Agenda Item 3 1190 Inverlieth Road Demolition of Existing Garage, Construction of Replacement Garage & Driveway Reconfiguration

Chairman Grieve and members of the Historic Preservation Commission

SUBJECT:

1190 Inverlieth Road - Demolition of Existing Garage, Construction of Replacement Garage, Driveway Reconfiguration and Tree and Vegetation

PROPOSED SITE PLAN

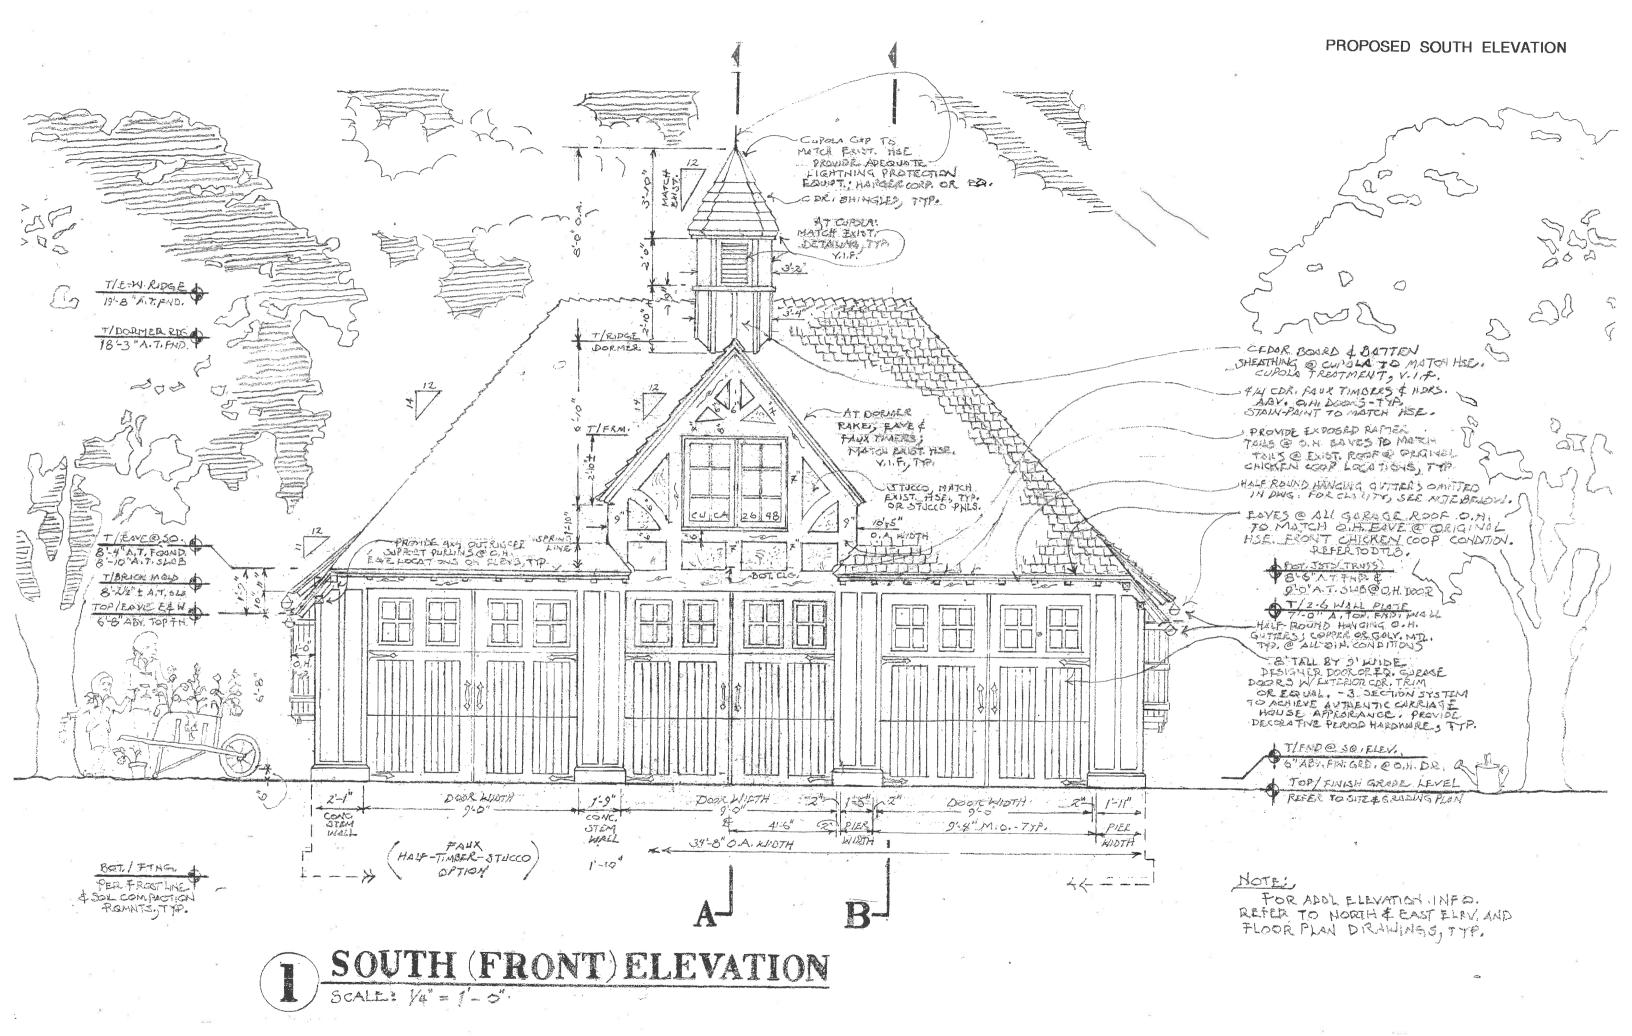
The existing curb cut will remain and an extension of the driveway is proposed to the north to provide access to the new garage. As reflected on the plans submitted by the petitioner, the existing circular portion of the driveway on the southeast side of the property will be removed. The patio and walkway between the circular portion of the driveway and the existing residence will also be removed.

Based on information submitted by the petitioner, the amount of impervious surface on the site will increase from coverage of 27 percent to 29 percent. Consideration should be given to use of some pervious materials for a portion of the driveway in an effort to minimize the increased impervious surface on the site. Stormwater runoff from this property on to the adjacent lot to the west has been a concern in the past. Prior to the issuance of any permits for this project, the drainage and grading plan will be subject to review and approval by the City Engineer.

- 1. A detailed drainage plan, as approved by the City Engineer, must be in place prior to the issuance of any permits for work related to this project. In reviewing the plan, consideration shall be given to:

- a. Reduction in the amount of impervious surface on the site.
 - b. Incorporation of a curb on all or portions of the west side of the driveway.
 - c. Installation of stormsewer on the site.

PRELIMINARY LANDSCAPE PLAN

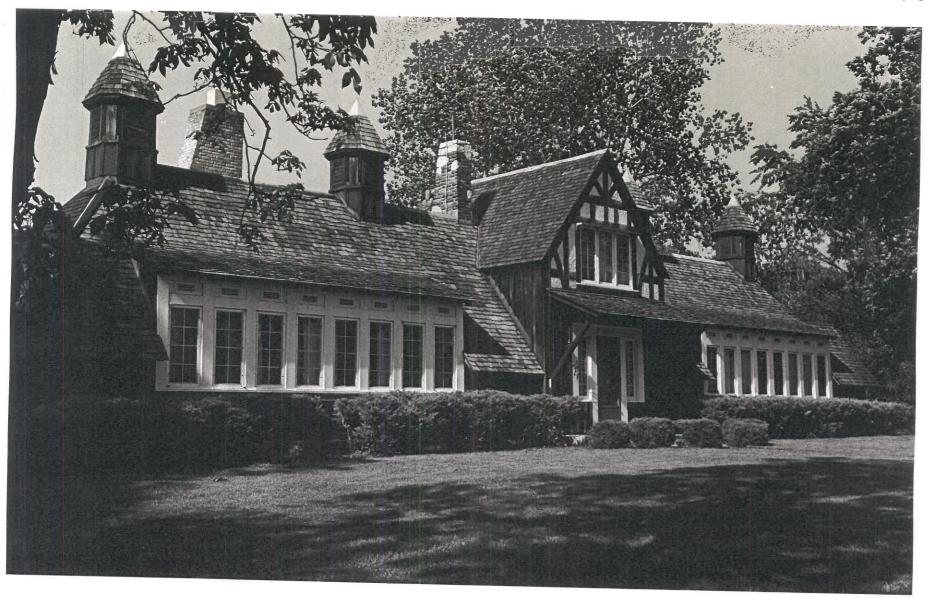
The conceptual landscape plan submitted by the petitioner reflects new plantings in the southwest corner of the site and along the east property line. Due to the clearing of vegetation that has occurred along the west side of the property additional plantings need to be incorporated into the plan to provide landscape screening along the west property line.

- 4. A final landscape plan shall be submitted and will be subject to review and approval by the City's Certified Arborist. Replacement plantings as determined to be required shall be reflected on the final landscape plan. The plan shall reflect replacement plantings to provide for a landscape buffer along the west property line.

Proposed Site Plan HPC 0.2 Woodprince Residence

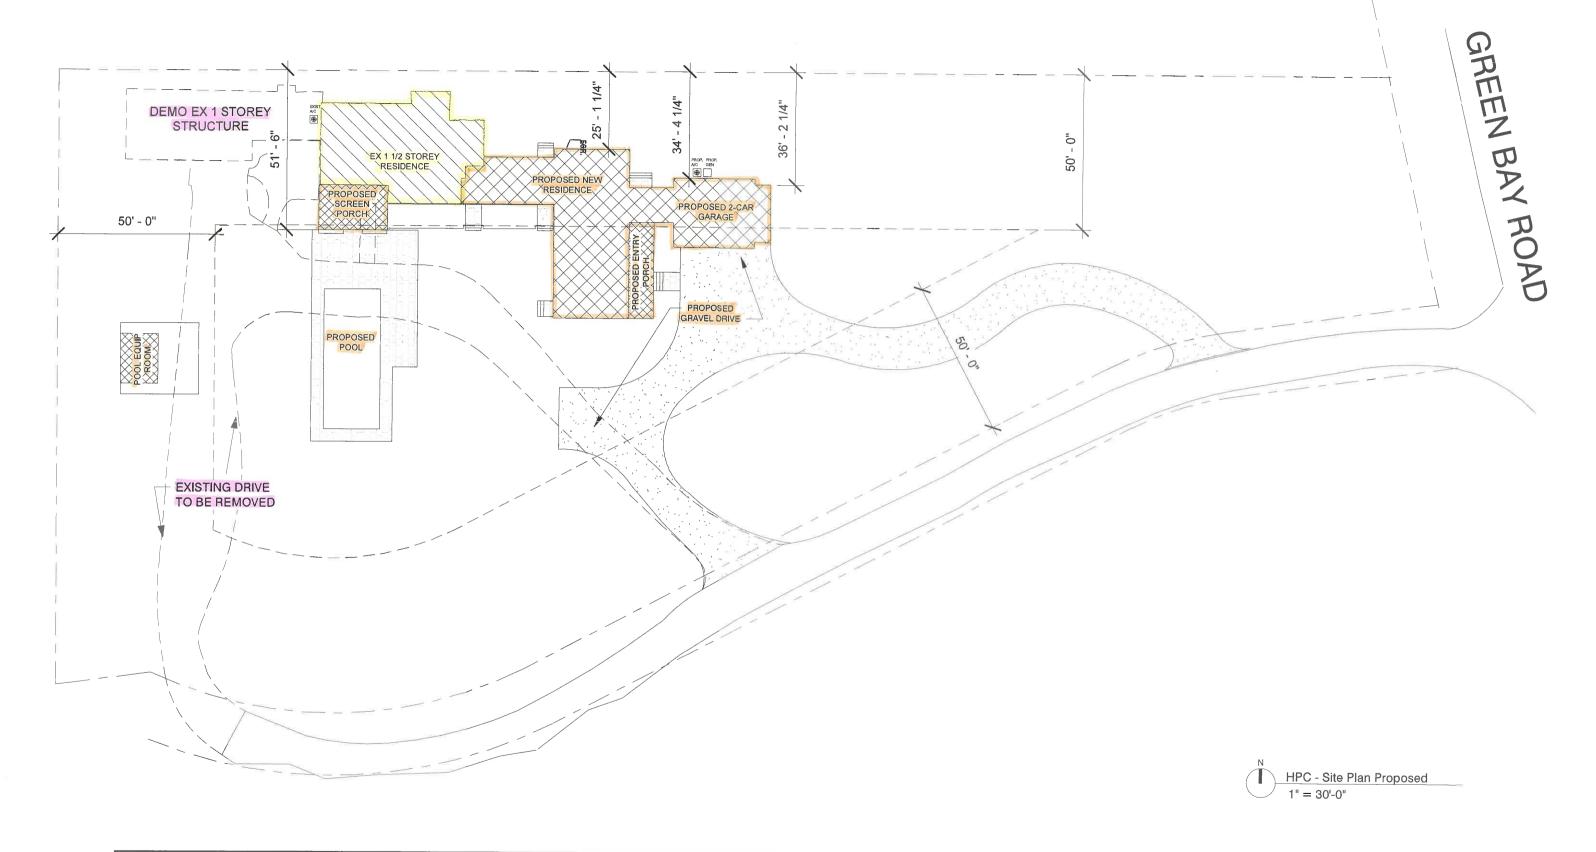
Most of the existing driveway will be removed. A new driveway configuration is proposed and is reflected on the site plan submitted by the petitioner. As proposed, the driveway will separate from the driveway that is shared with the neighbor, providing more privacy for both property owners.

LANDSCAPE PLAN

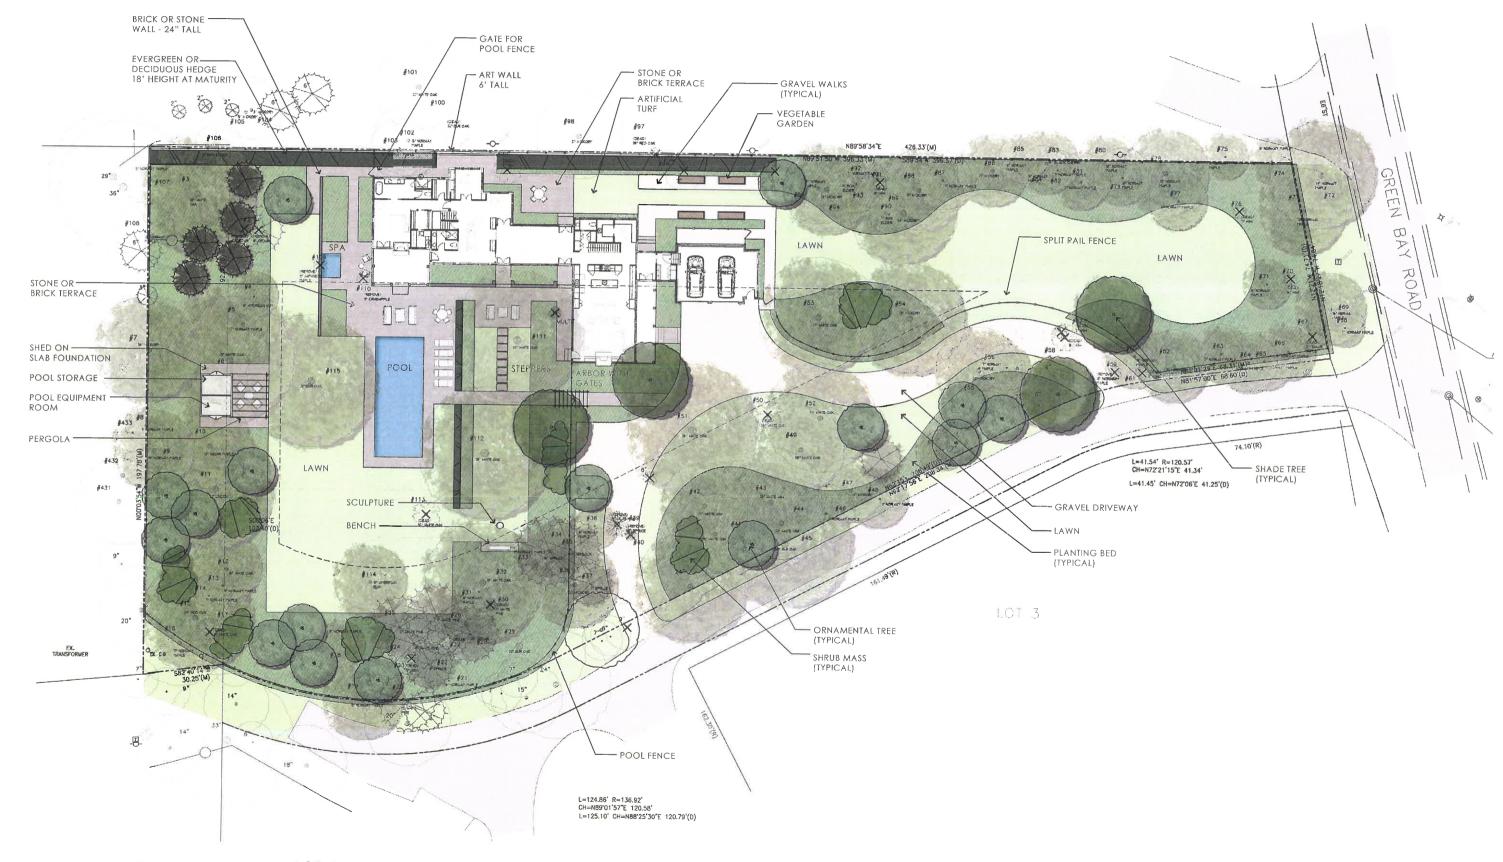
The preliminary landscape plan submitted by the petitioner reflects a mix of shade and evergreen trees and shrub and ornamental plantings across the property. Based on the preliminary landscape plan, the total number of replacement inches may be able to be fulfilled through on site plantings.

- 3. The final landscape plan shall be subject to review and approval by the City Arborist. The plan shall provide for at least 33 replacement tree inches on site. If full replacement on site is not possible in a manner consistent with good forestry practices, payment in lieu of on site planting will be required prior to the issuance of a Certificate of Occupancy. If during construction, additional trees on the site are compromised in the opinion of the City's
